AGENDA
CITY OF STURGEON BAY
CITY PLAN COMMISSION
Wednesday, March 16, 2016
7:00 p.m.
Council Chambers, City Hall
421 Michigan Street

STAFF REPORT TO CITY PLAN COMMISSION
Final PUD – The Bay Lofts Mixed-Use Development

THE BAY LOFTS

FINAL PUD SUBMITTAL

Preliminary Grading & Drainage Plan

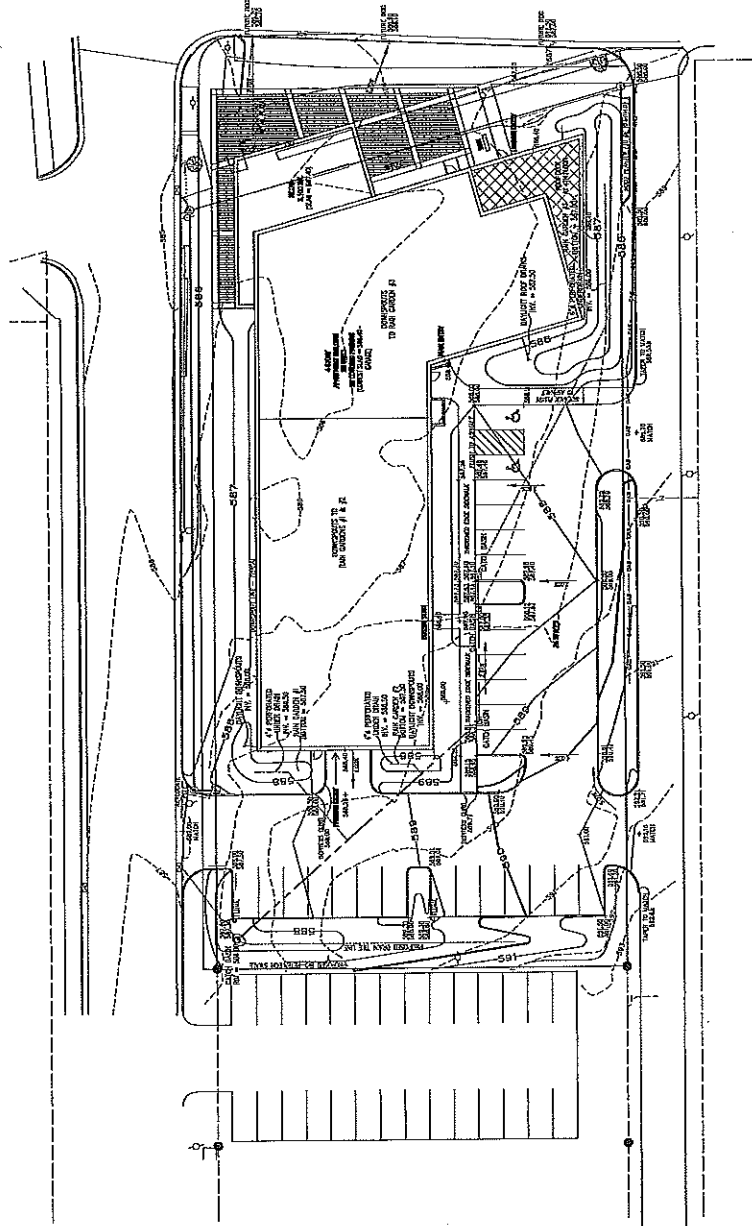
Storm Water Management – The plan mitigates runoff from the roof by directing it into various rain gardens to improve infiltration. A portion of the parking area is directed into a grass swale along the west property line and a portion is directly routed into the municipal storm sewer. All of the runoff that is not infiltrated eventually reaches the storm sewer system. The previous development had no storm water management controls. Since the

amount of impervious surfaces is less after the redevelopment and a large portion of the runoff is now being treated, the plan is supported. Final approval by the city engineer is required prior to construction beginning.

Preliminary Utility Plan

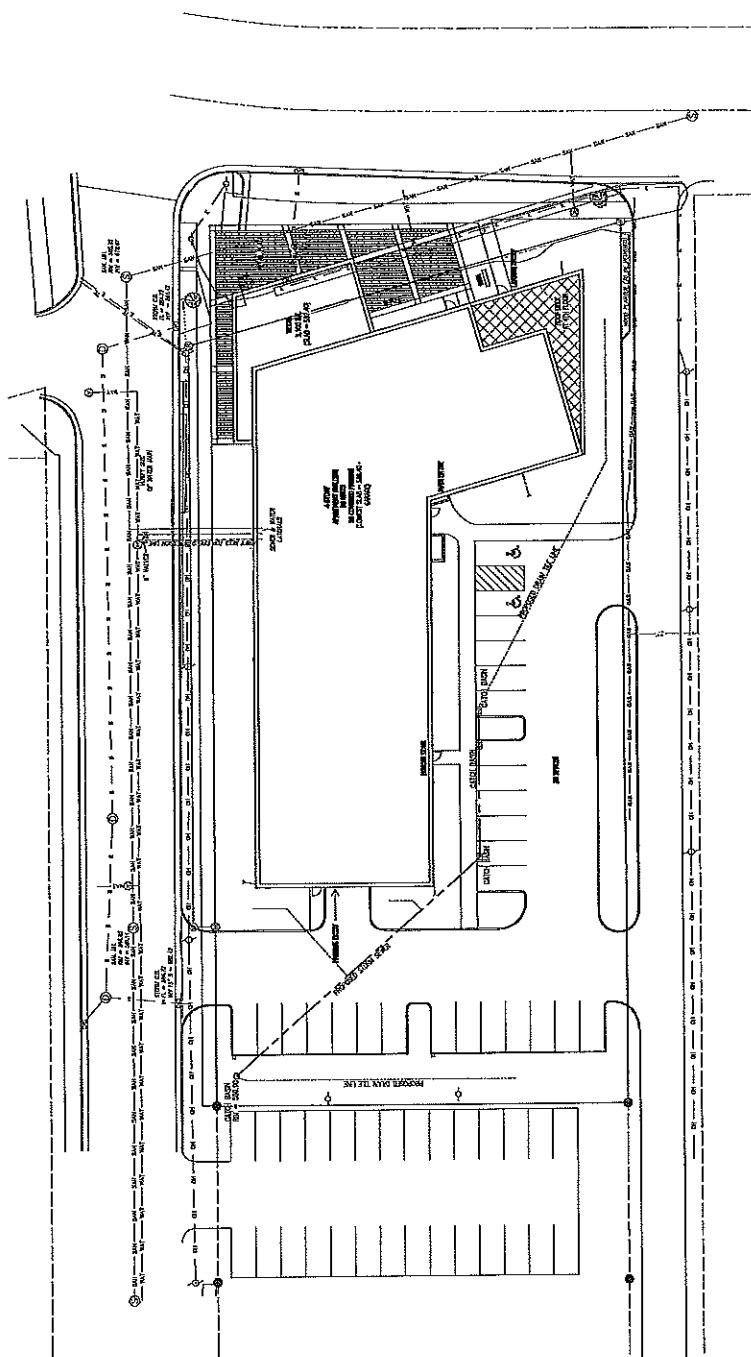
Utilities – The project can easily be served by existing utility lines and there are no concerns. Sturgeon Bay Utilities has submitted a plan showing how the existing overhead utility lines along Larch Street can be placed underground.

⑥ NORTH ELEVATION (LARCH STREET)
1/8" = 1'-0"

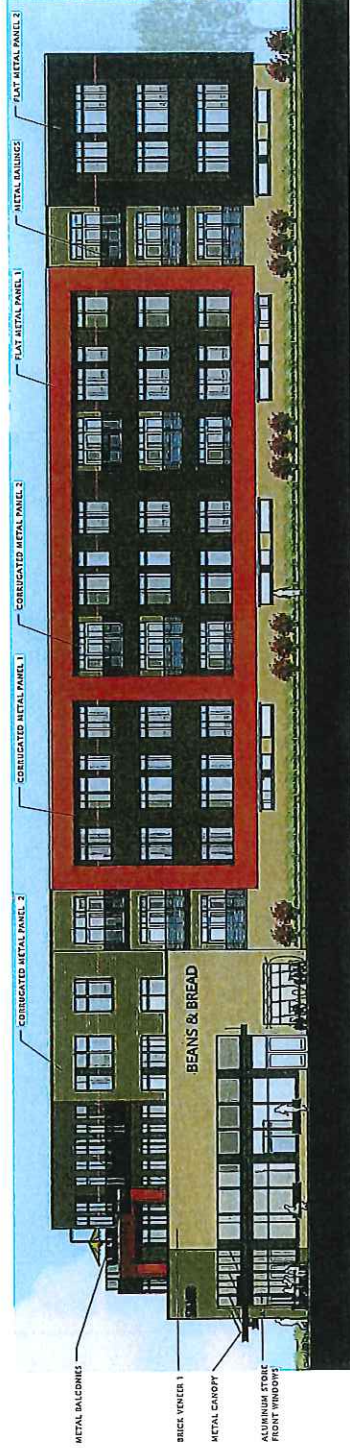
Exterior Elevations: Based upon the comments from the preliminary PUD review, the developers have submitted a somewhat different facade for the Larch Street facing exterior. The new plans call for a few 'breaks' in the exterior and a change in the corner coloring.
